REQUEST

Current Zoning: RE-2 (research) and RE-2(CD) (research, conditional)
Proposed Zoning: R-12MF(CD) (multi-family residential, conditional) with five-year vested rights.

SUMMARY OF PETITION

The petition proposes a residential community developed in two phases allowing up to 712 multi-family and 26 townhome dwelling units with a density of 9.6 dwelling units per acre on vacant land.

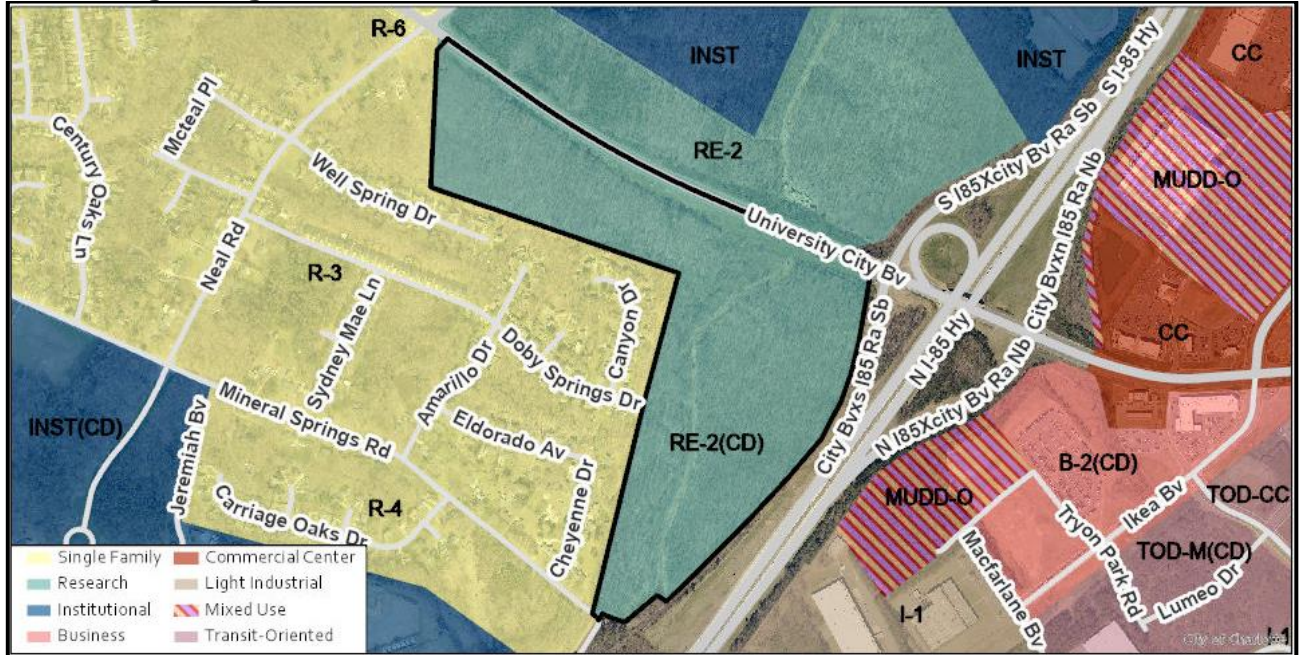
1. Revise the site plan and conditional note(s) to commit to constructing a shared use path connection to Mineral Springs Road

2. Add an evergreen tree and shrub species to the buffer planting schedule.
